# FLEET OPERATIONS

February 28, 2014

## Attention: BC Ambulance Service Representative

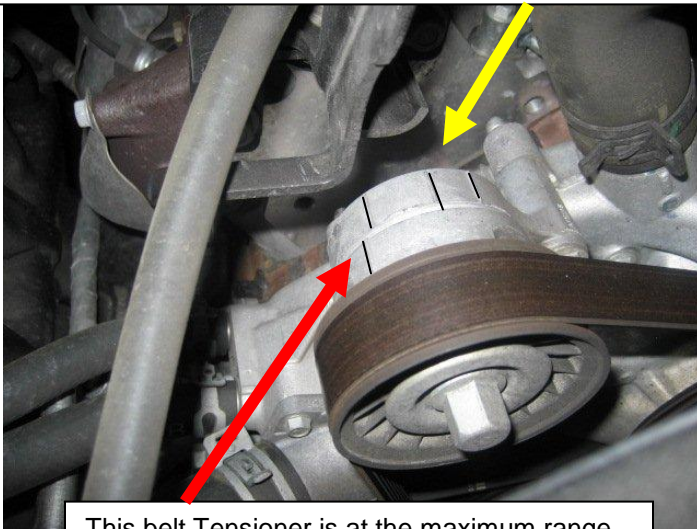
There have been instances on the Chevrolet gasoline engine ambulances where the serpentine belt prematurely wears and emits an audible chipping noise. Due to inconsistencies during manufacturing, ambulance manufacturers may have installed an incorrect sized idler pulley between the two alternators.

Belt Tensioner hash mark needs to be in the middle range

This belt Tensioner is at the maximum range

Idler pulley in question

At the next scheduled A service inspect the serpentine belt tensioner for correct positioning.

If your Chevrolet gasoline engine belt tensioner has exceeded the maximum position as shown in the picture – Contact the ambulance manufacturer (Crestline or Demers) for the correct idler pulley (and belt) for warranty replacement.
